Agenda
City of Springboro Planning Commission Meeting
Wednesday, March 8, 2023, 6:00 p.m.
Council Chambers, City Building, 320 West Central Avenue

Site Plan Review, 800 West Central Avenue (SR 73), proposed Sheetz fuel center, convenience store/restaurant

Site Plan Review, 25 West Central Avenue (SR 73), new bank branch for River Valley Credit Union

Drawing Title: UTILITY PLAN

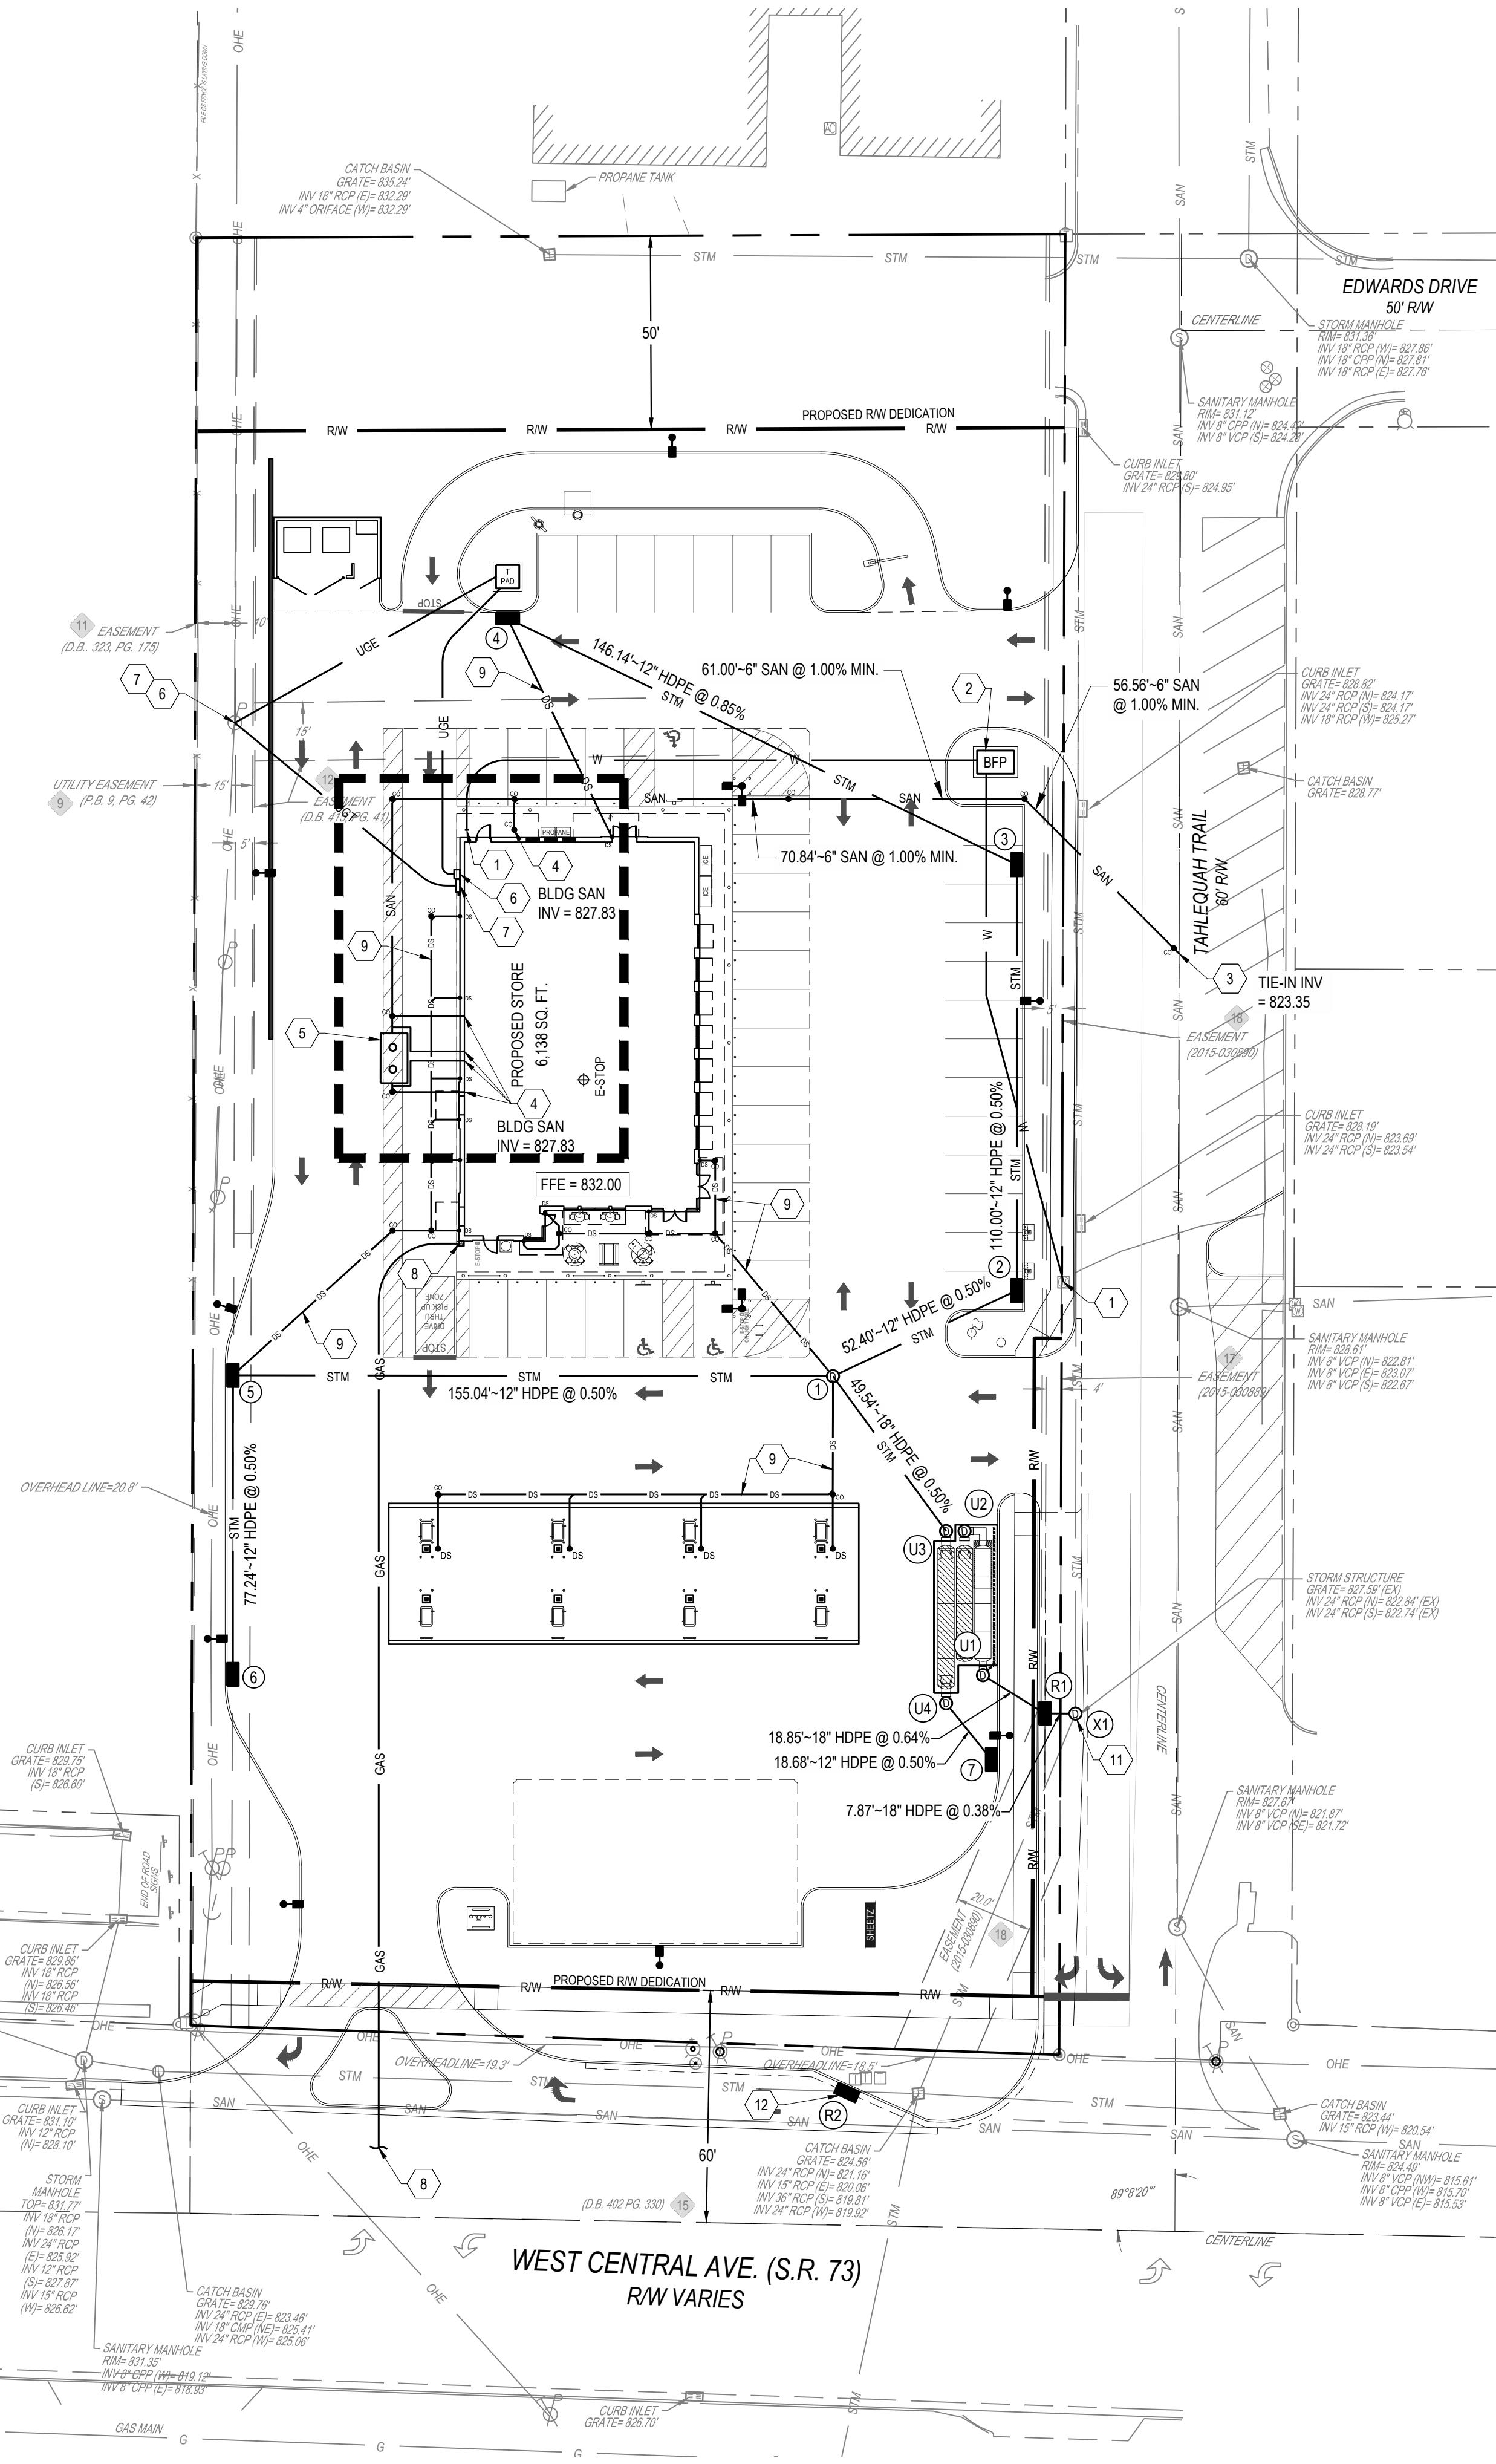
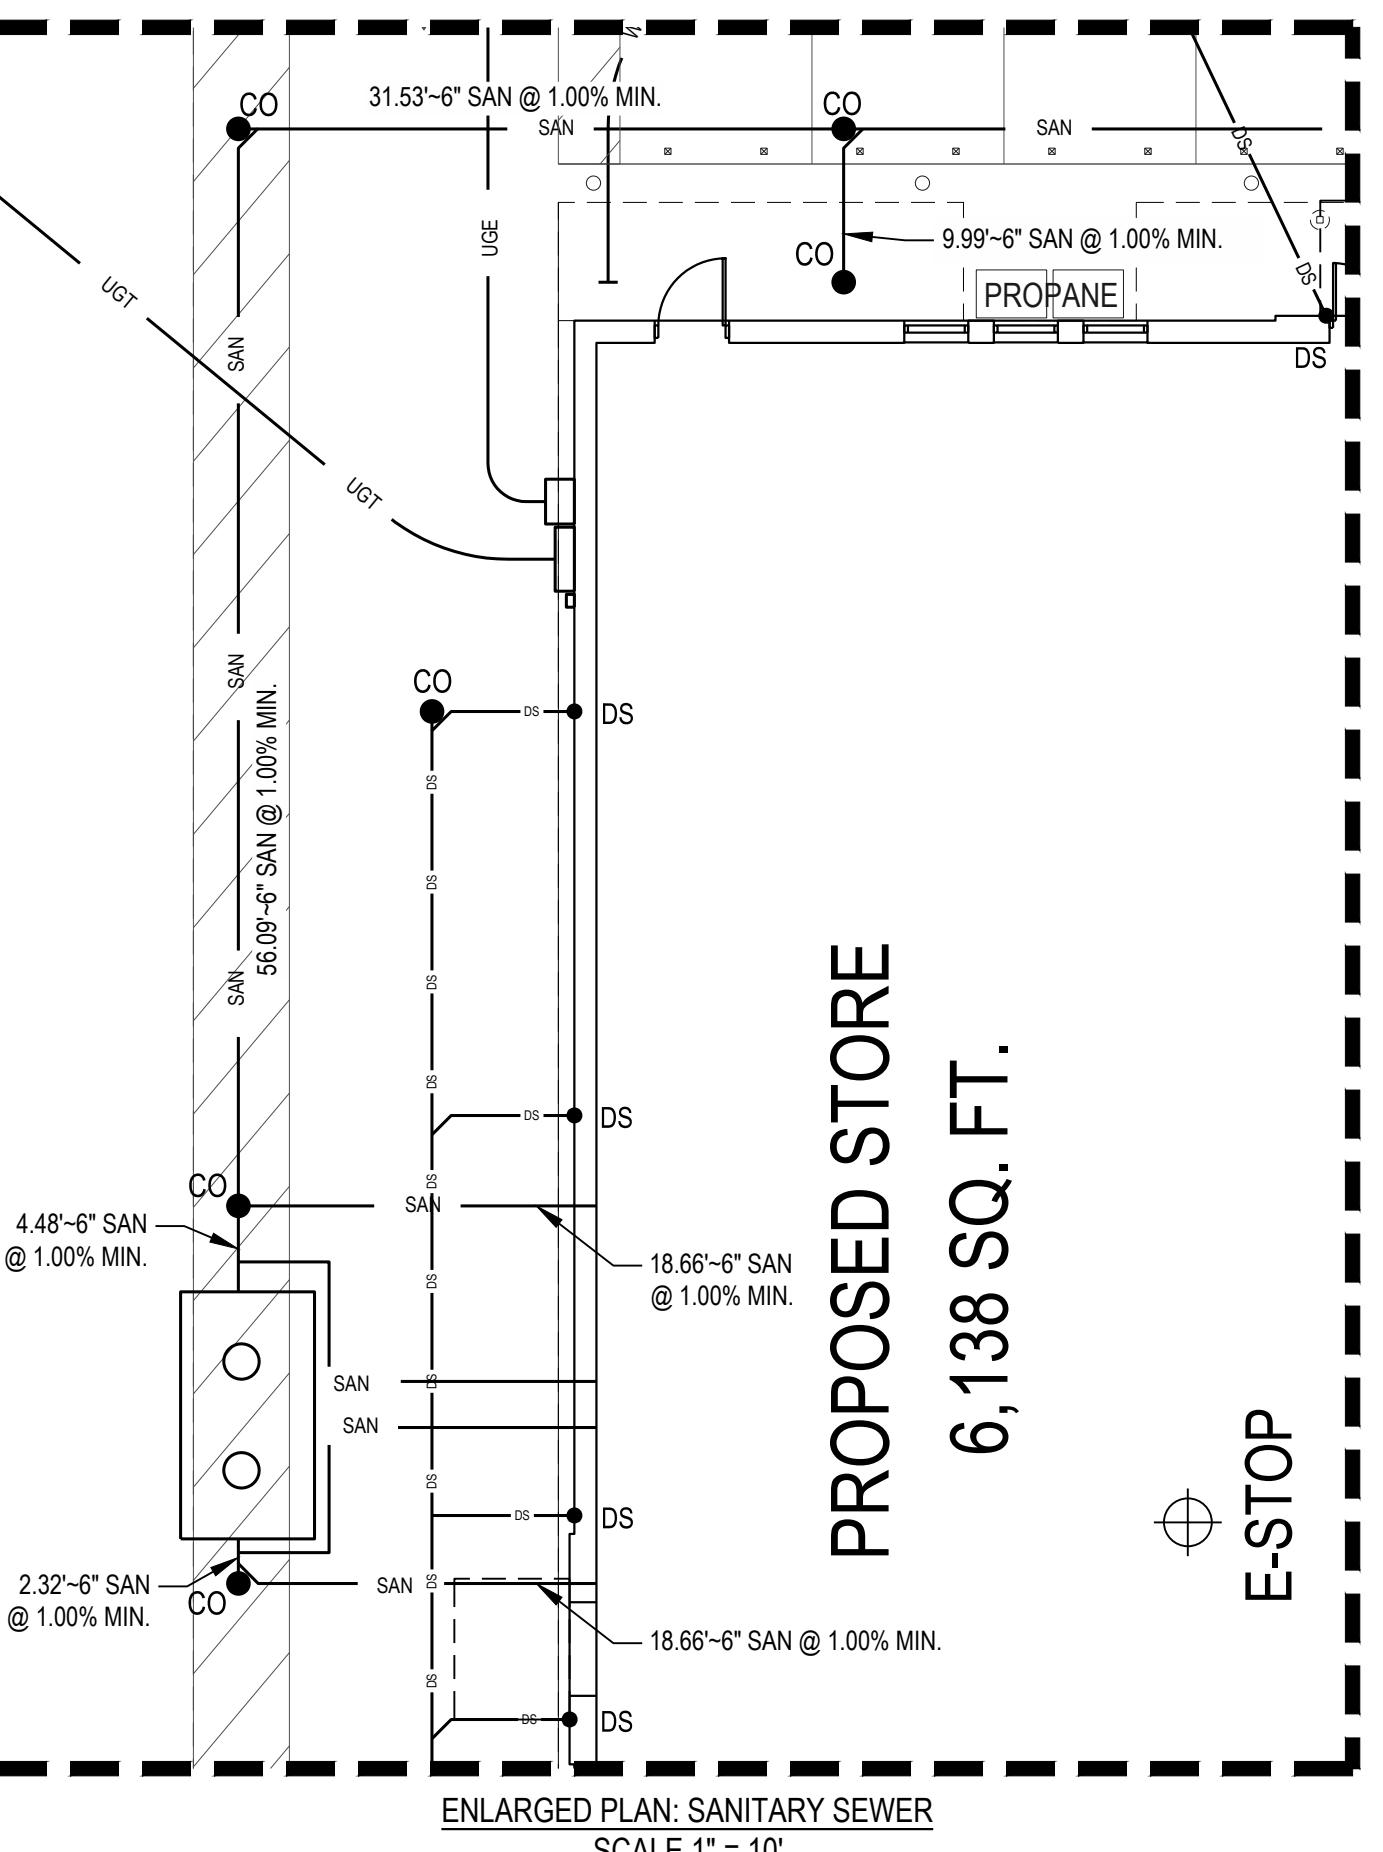
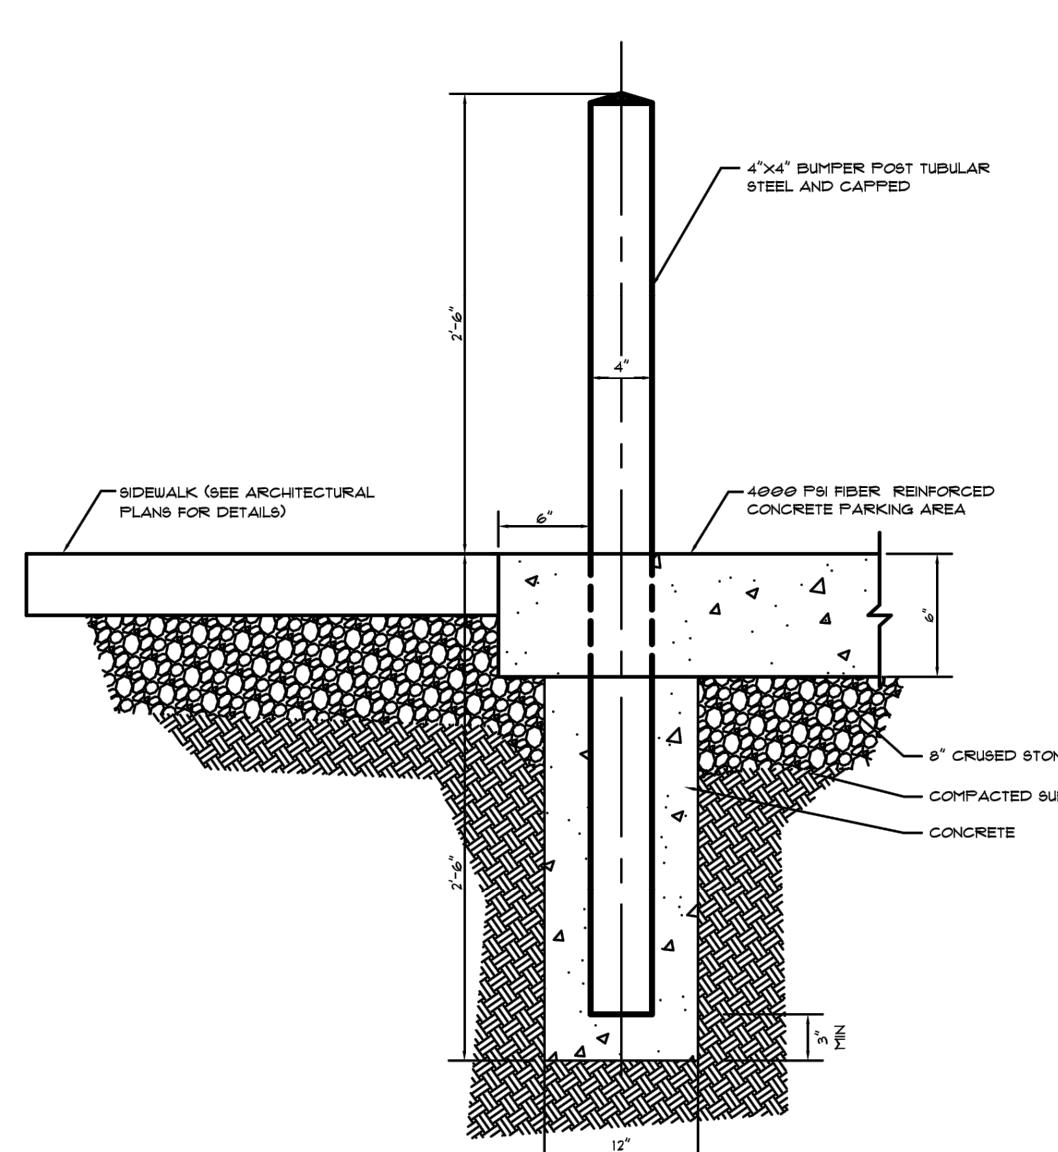
5. Water main minimum cover is 54". Provide existing water main location along West Central Avenue and Tahlequah Trail. Show the location of the proposed water lateral tap to the existing water main along Tahlequah Trail, along with curb box located behind sidewalk. Meter pits are not permitted; water meter with remote reader to be located inside building,

remove details on sheet C7.4 accordingly and revise coded note 1 on sheet C5.0. A 2" plastic water main to be installed, being HDPE tubing (SDR 9, 250 PSI), with #14 AWG blue tracer wire. Provide pavement saw cut and pavement replacement details for water/sewer lateral taps. Delete coded note 2 on sheet C5.0.
